To: T10 Technical Committee  
 From: Rob Elliott, HP (elliott@hp.com)  
 Date: 16 April 2007  
 Subject: 07-177r0 SAS-2 Port layer wide port ordering

**Figure 1 — Wide connection examples**

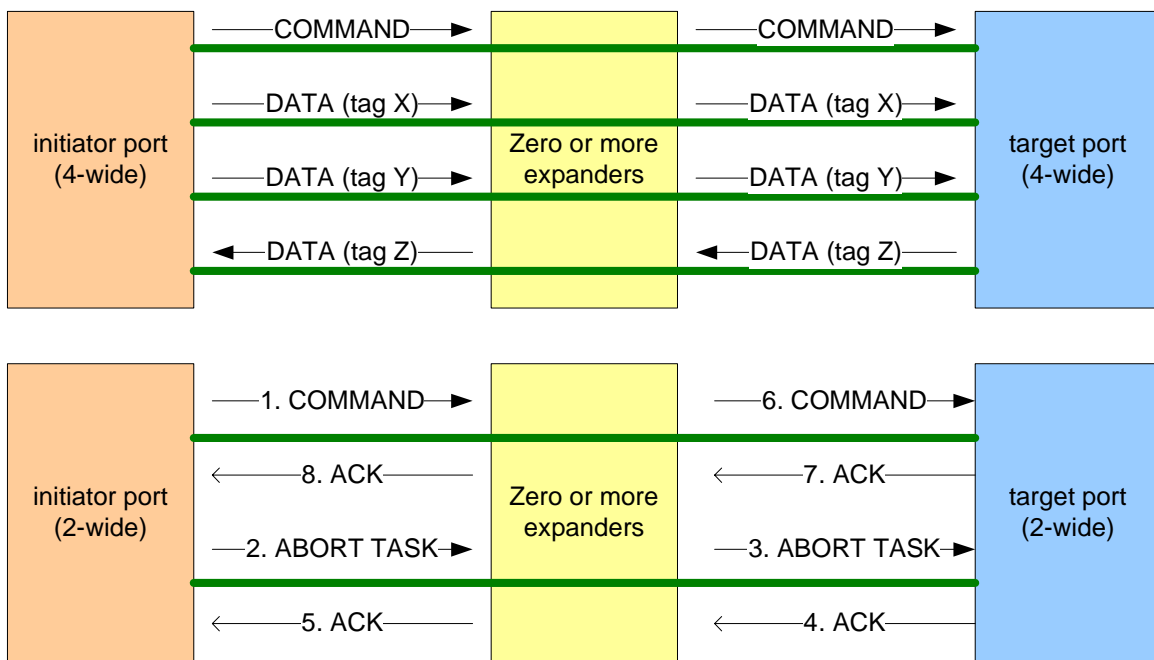
A wide port can have multiple connections open to another wide port at the same time. A port cannot prevent this from happening; for example, always rejecting the second incoming connection request could lead to a livelock if both ports implement that algorithm and their connection requests cross on different logical links. Although order is maintained within each connection, there is no ordering guarantee across multiple connections. If the wide port sends a frame on logical link 0 and then sends a frame on logical link 1, they might arrive at the destination in the original order, simultaneously, or in reverse order.

Provided it does not cause ordering problems, the wide port can and should send frames simultaneously on multiple logical links to take advantage of the extra bandwidth. This is particularly important for DATA frames, which are already non-interlocked within connections and should be allowed to be transferred concurrently with other frame types on other connections. It is not as critical for COMMAND, TASK, XFER\_RDY, and RESPONSE frames, which are already interlocked within each connection.
